**STAFF RECOMMENDATION**

**1403 Elmwood Avenue**

**April 20, 2016**

**Application:** New construction-outbuilding; Setback determination

## Site Plan

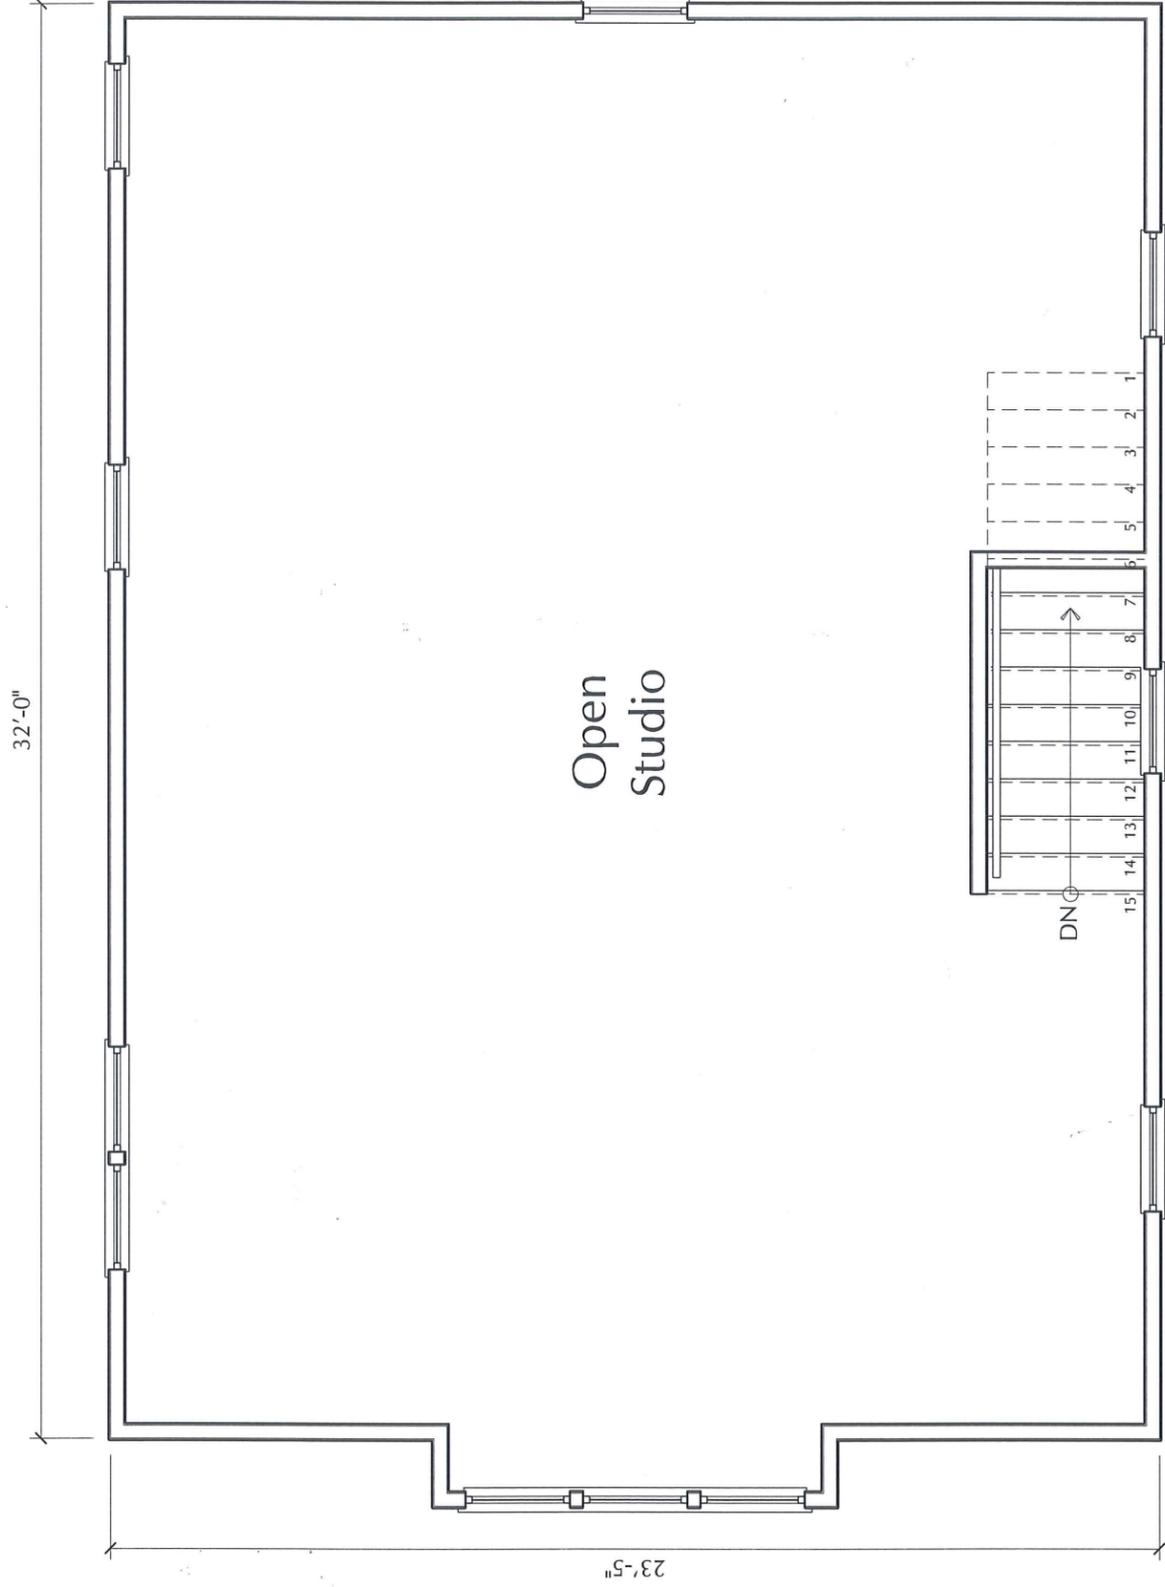
Setback & Rhythm of Spacing: The applicant requests a rear setback of ten feet (10'). An outbuilding with a footprint over seven hundred square feet (700 sq. ft.) is required by Code to be twenty feet (20') from the rear property line. Historically, outbuildings were located on or close to the rear property line. There are numerous outbuildings nearby that sit nearer to the alley than ten feet (10'). Staff finds that the setback determination meets the design guidelines.

Staff recommends approval of the outbuilding and the setback determination with the conditions:

1 South Elevation  
 Scale: 1/4" = 1'-0"

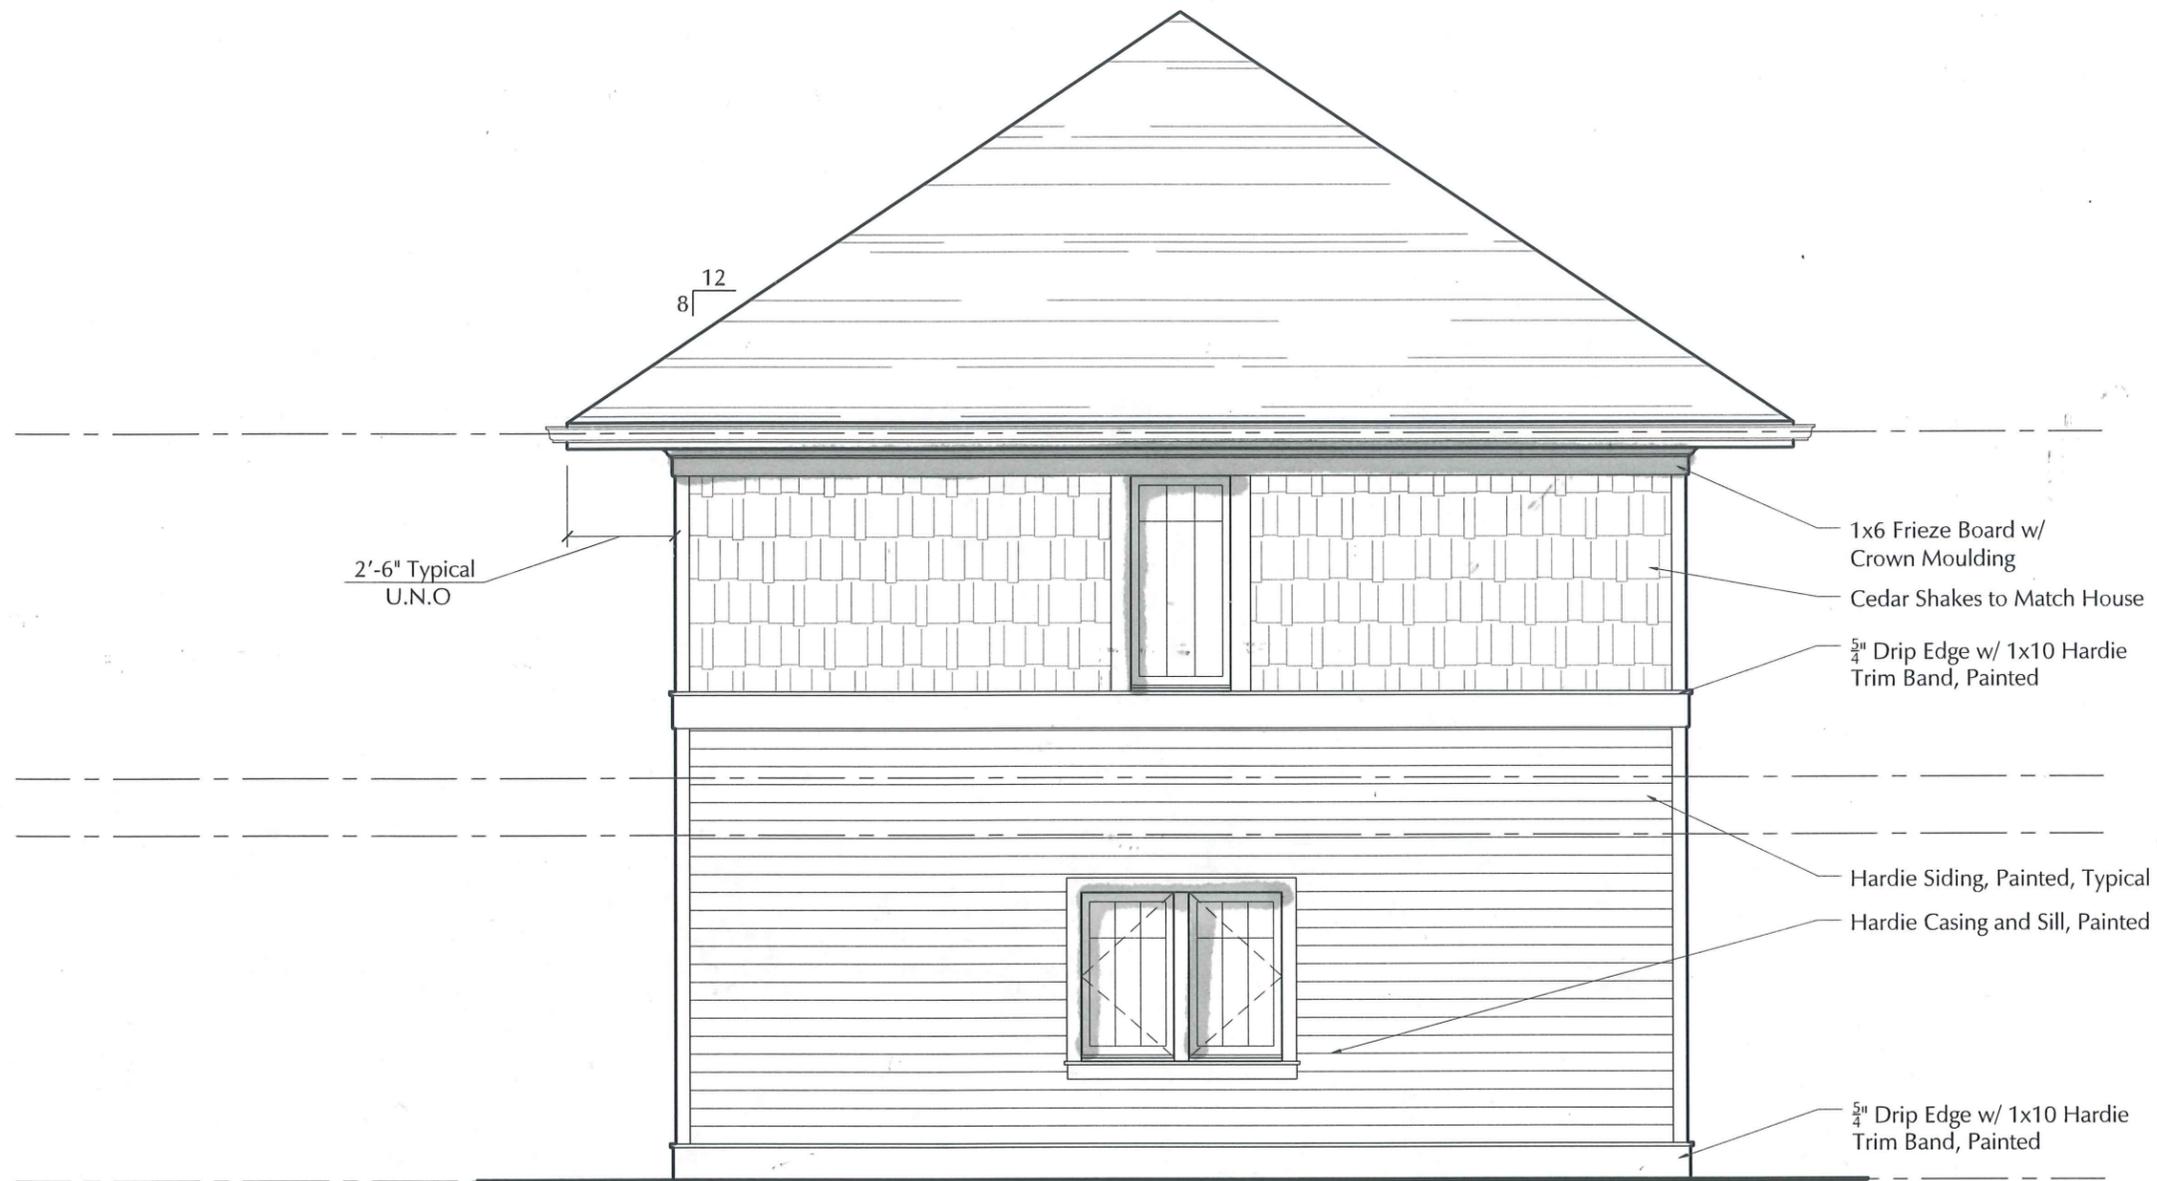
Height & Scale: The outbuilding is drawn with a ridge height of twenty-seven feet (27'). The Belmont-Hillsboro design guidelines limit the height to twenty-five feet (25'). In 2014 the Commission hosted a series of charrettes to gain input from the neighborhoods about additions, infill and outbuildings. Participants agreed that they wanted the requirements for detached accessory dwelling units (DADUs) and garages to be the same. DADUs are not allowed to exceed twenty-five feet (25') in height, according to the ordinance. (Staff has also researched DADUs in other cities and have not found any that exceed twenty-one feet (21') in height. In fact, many are significantly shorter.) In order to clarify design guideline II.B.i.1. for outbuildings, which states that outbuilding should be compatible by not contrasting greatly with surrounding historic outbuildings in terms of height, italicized information was added to explain that outbuildings should not exceed twenty-five feet (25') in height.

Staff therefore recommends that the ridge height be reduced to twenty-five feet (25').
